FILE: STP00-0159-01(014) Meriwether **OFFICE:** Engineering Services
P.I. No.: 321880
CSX Railroad Bridge over SR 41 **DATE:** September 29, 2009

SUBJECT: IMPLEMENTATION OF VALUE ENGINEERING STUDY ALTERNATIVES

FILE: STP00-0159-01(014), Meriwether County
P.I. No. 321880
Replacement of CSX RR Bridge over SR 41

SUBJECT: Value Engineering Study-Responses

ATTACHMENT 1

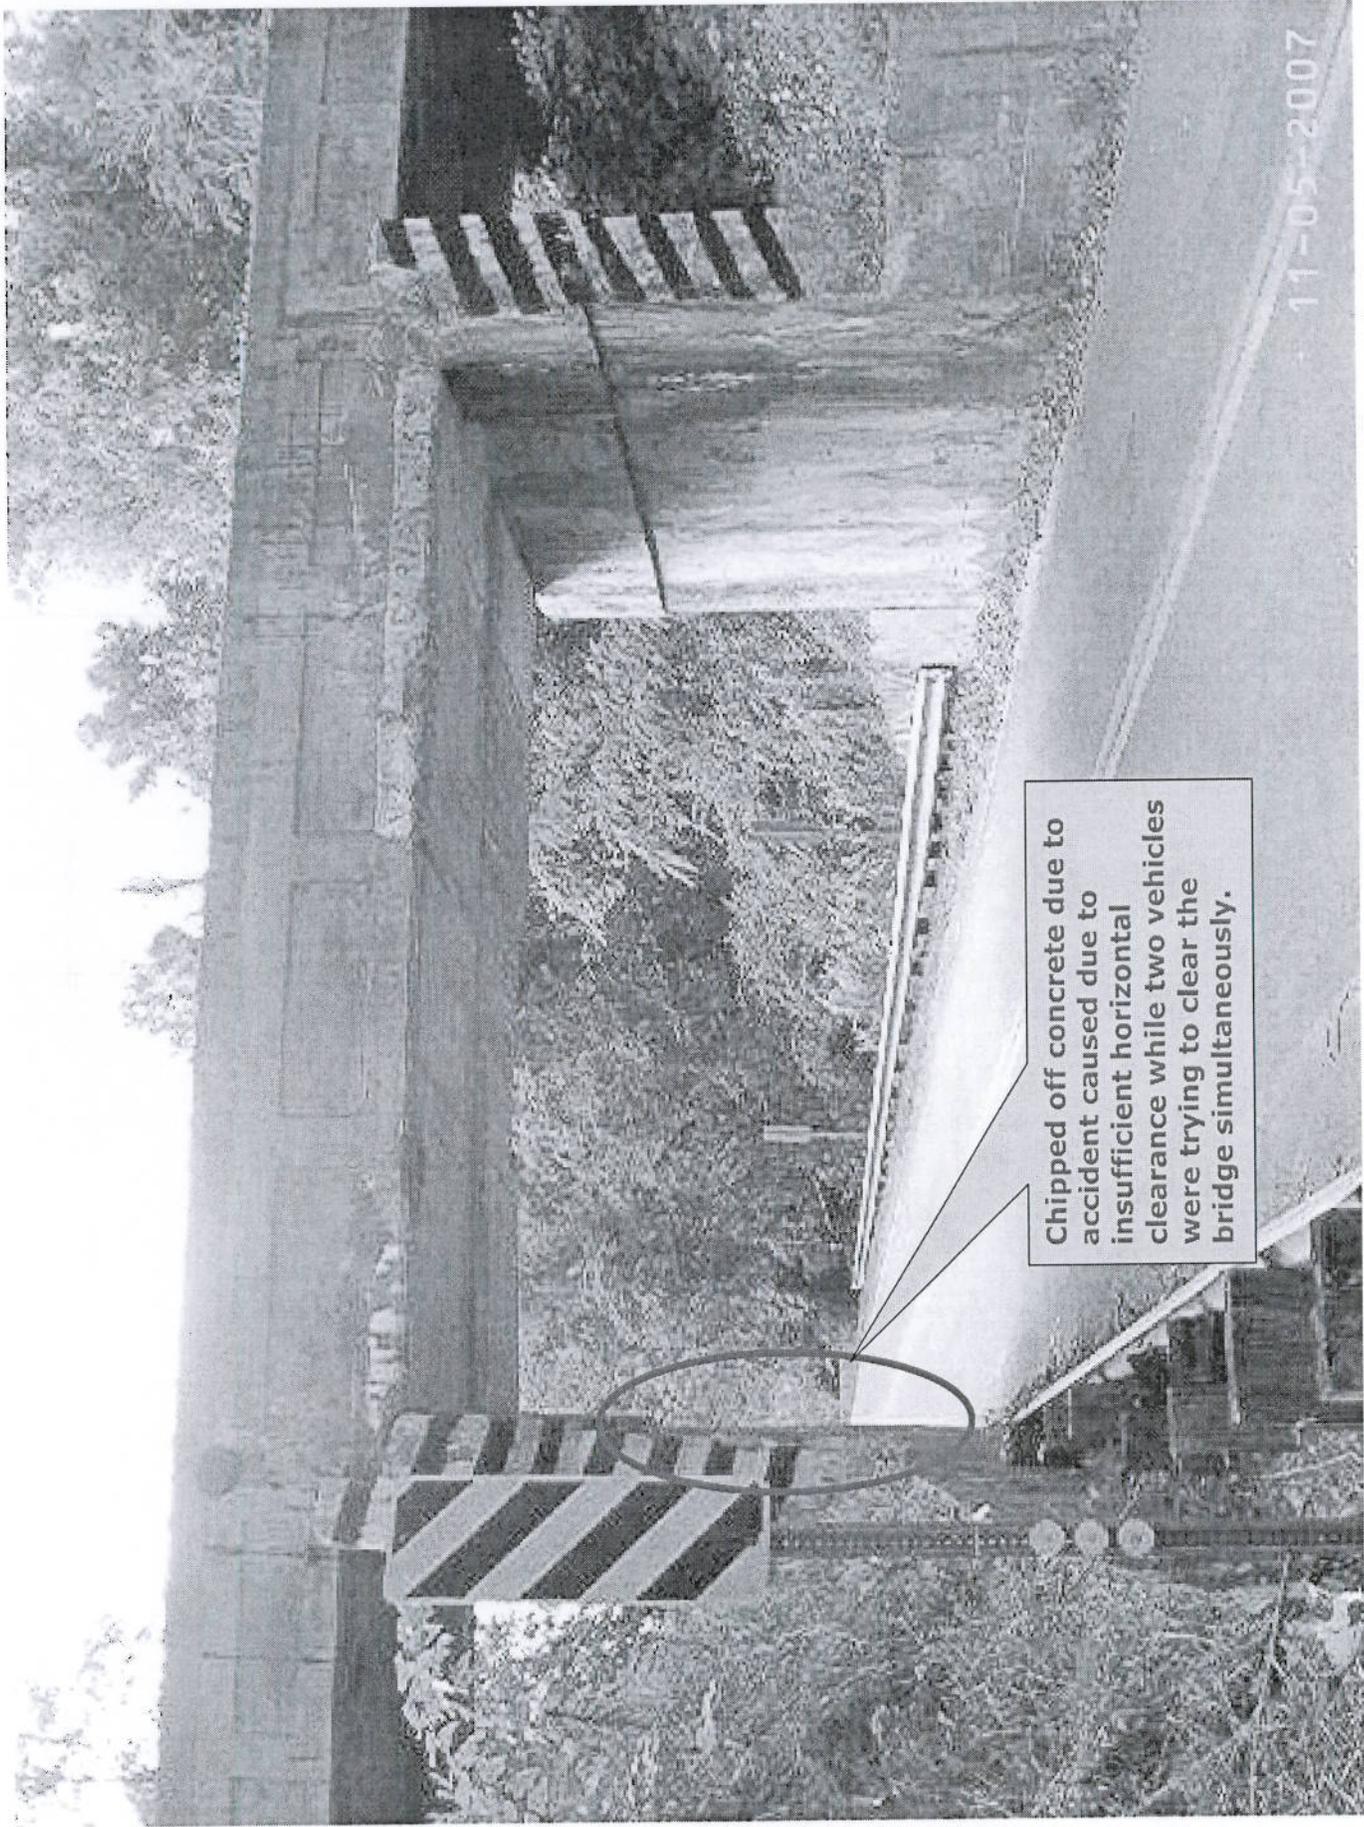
Chipped off concrete due to accident caused due to insufficient horizontal clearance while two vehicles were trying to clear the bridge simultaneously.

Chipped off concrete due to accident caused by vehicle trying to cross the bridge with insufficient vertical clearance.
